Product / Process Change Notification (PCN)

PCN #: PCN_conTBL7_20230810

Affected Series: WE-TBL7 6917097103xx,

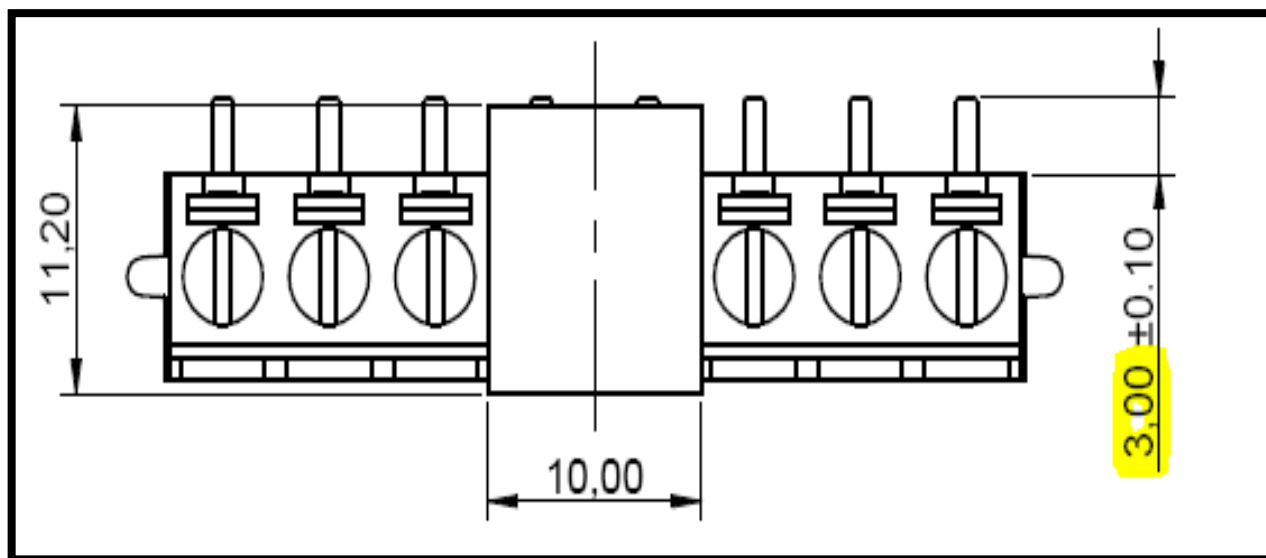
To ensure an improved product assembly, Würth Elektronik, will change the length of the pin and reinforce the housing to avoid movement from the pin.

All products with date code 2023-03-01 or later, will be affected by this change.

Detail of Change:

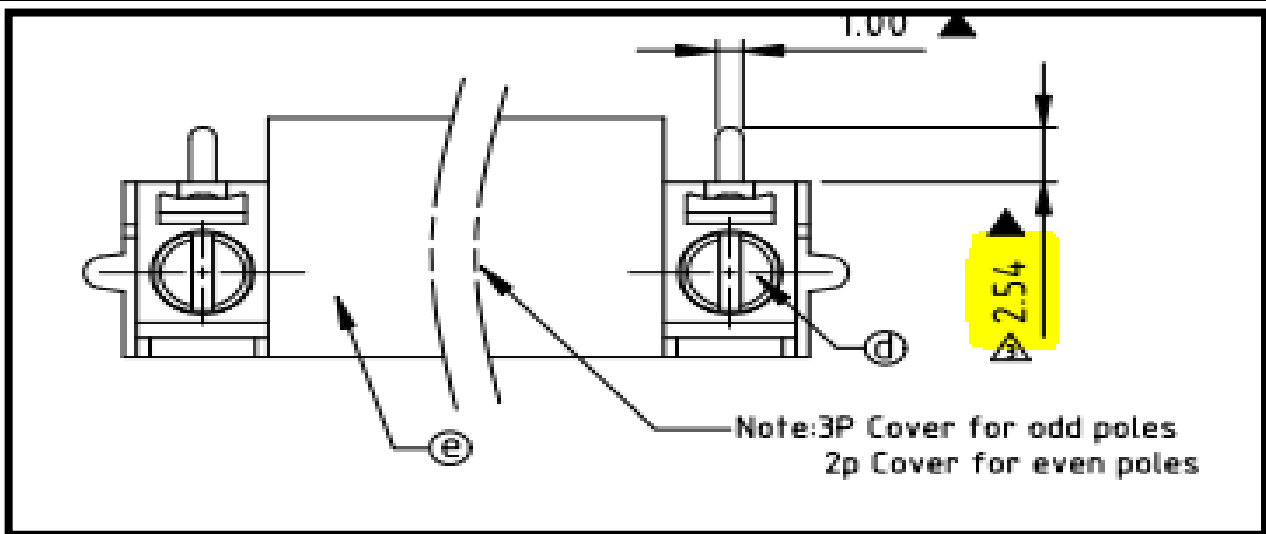
The pin Length 3mm will be changed to 2.54mm.

Change Details	L (mm)
BEFORE	3
AFTER	2.54
